**DISTRIBUTION
PROJECT MANAGERS' MEETING,
200 AREA GROUNDWATER SOURCE OPERABLE UNITS
March 18, 2010**

Meeting Minutes Transmittal/Approval
Project Managers' Meeting
200 Area Groundwater and Source Operable Units
March 18, 2010

Change Notice Number TPA-CN- 335	TPA CHANGE NOTICE FORM	Date: 03/15/2010
Document Number, Title, and Revision: DOE/RL-2006-57 Rev 0 Reissue, <i>Sampling and Analysis Plan for Supplemental Remedial Investigation Activities at Model Group 5, Large-Area Ponds, Waste Sites Located Within the 200-CW-1 Operable Unit.</i>		Date Document Last Issued: 02/28/2008
Originator: Briant L. Charboneau		Phone: 373-6137

Figure 3-6. Planned Geophysical Logging and Soil Sampling Locations at the 216-U-10 Pond.
See Table 3-1 for sample details.

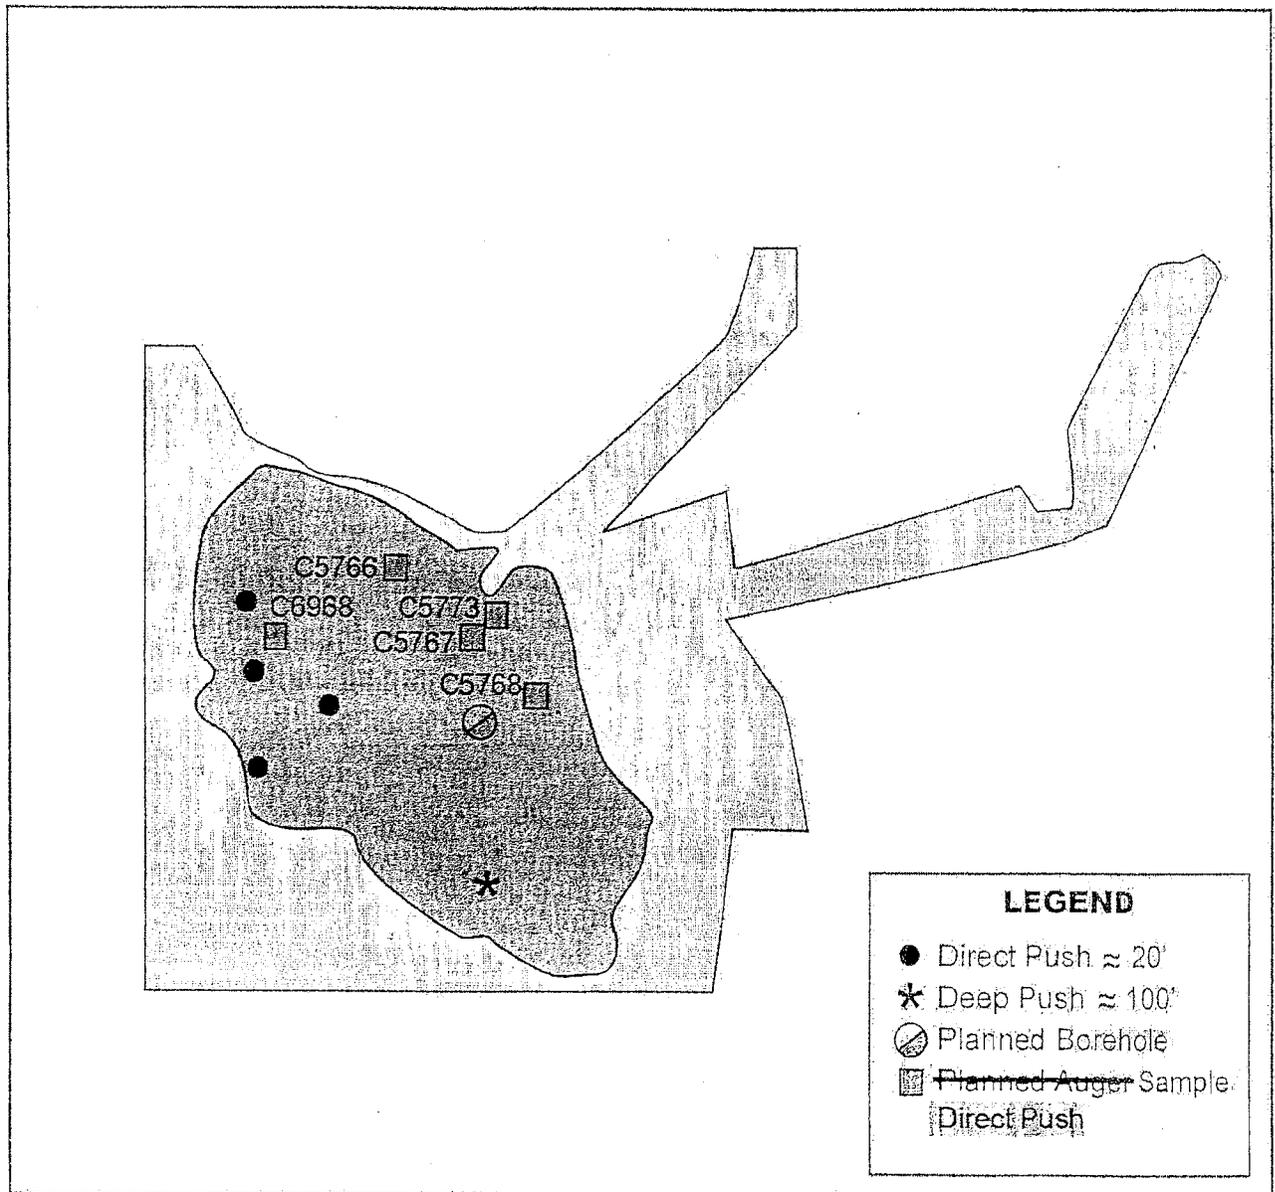
Description of Change:
Eight samples for characterization of the 216-U-10 Pond waste site from C5766, C5767, C5768 and C5773, will be collected via four direct pushes instead of four auger holes.

Specific changes:
Table 1-7, Page 1-19, Each 'auger' is replaced with 'direct push' and the number of samples is corrected from 6 to 8
Section 3.1.4, Page 3-4, 'hollow stem auger' is replaced with 'direct push' and text related to only samples via an auger is deleted.
Section 3.1.4, Page 3-5 'auger' is replaced with 'direct push'
Figure 3-6, Page 3-12, 'Planned Auger Samples' is replaced with 'Direct Push Sample' and borehole numbers are added
Table 3-1, Page 3-20, Each 'auger' is replaced with 'direct push' and the number of samples is corrected from 6 to 8
Table 3-2, Page 3-22, Each 'auger' is replaced with 'direct push' and the number of samples is corrected from 6 to 8. The numbers of total samples, boreholes and samples are updated/corrected. 216-U-11 'Ditch' is corrected to "Pond". No. of shallow Pushes for 216-U-10 Pond is corrected to 5 to include the 'worst case location' specified on Table 1-7.

Justification and Impacts of Change:
Radiation Controls assessment of the 216-U-10 sampling plan based on the results of the geophysical logging completed in Summer 2008, resulted in a strong recommendation for changing augers to direct pushes to obtain the samples. The required samples at and below the organic mat (pond bottom) will be obtained using direct pushes.

Due to the contamination levels expected, a number of additional controls would be needed mainly due to the additional volume of soil produced by the auger. These would likely include a full enclosure and additional personal protective equipment.

With the change to direct push, the required samples can be made without the additional controls needed to protect workers and the environment.
